In follow up to the new plan that was presented for the Dupee St 40B project on 12/2/20, I have a few comments and concerns to share with the board:

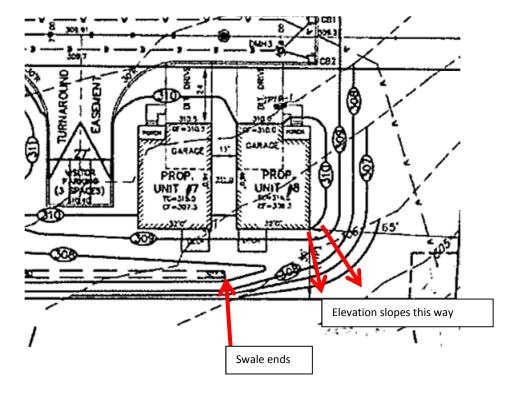
Based on the existing proposal presented on 12/2/20, we do not feel that Mr Petrozzi has adequately addressed these concerns with the proposed privacy plan. He has proposed 1 row of 4-5ft arborvitaes planted 6-8 feet apart. They are not staggered.

4-5 ft arborvitaes are tiny trees. It will take at least 4-5 years for the trees to grow and mature for us to have any real privacy. The proposed homes are 2.5 stories, with the decks .5 levels up. The decks will actually be taller than the trees during the initial years and the residents will be looking right into our first floor. We recently planted 4-5 ft trees, 3 feet apart on the side of our house(see picture). As you can see, these provide NO privacy currently, and they are 3 feet apart vs the proposed 6 feet apart. (For context, my daughter in the photo is 26 inches tall)
